Product Change Notice (PCN)

PCN Number: PCN-0456204R-01

Product(s) Affected: SJ1-351XN Series (Parts: SJ1-3513N, SJ1-3514N & SJ1-3515N)

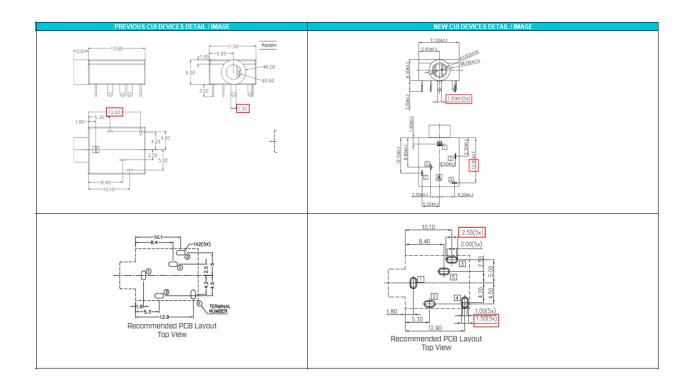
Description of Change: New Factory Location. Product re-engineered for improved manufacturability and production yield. See image below for reference and check CUI Devices website for updated drawing. Cosmetic differences may be visible and will not affect the form fit and function of the product.

DESCRIPTION MATERIAL PLATING/COLOR DESCRIPTION MATERIAL PLATING terminal 1 brass t=0.3 silver terminal 1 brass t=0.3 silver ov terminal 2 phosphor bronze silver terminal 2 copper alloy t=0.25 silver ov	,
phosphor broads	
phosphor bronze situate terminal 2 conner alloy t=0.25 silver ov	er nickel
terminal 2 t=0.3 silver dv	er nickel
terminal 3 brass t=0.3 silver terminal 3 copper alloy t=0.25 silver ov	er nickel
terminal 4 brass t=0.3 silver terminal 4 brass t=0.3 silver ov	er nickel
terminal 5 phosphor bronze silver terminal 5 brass t=0.3 silver ov	er nickel
t=U.3 bushing brass nickel	
bushing brass nickel cover PBT (UL94V-0) black	
spring steel black -	
cover PBT (UL94V-0) black housing PBT (UL94V-0) black	
housing PBT (UL94V-0) black
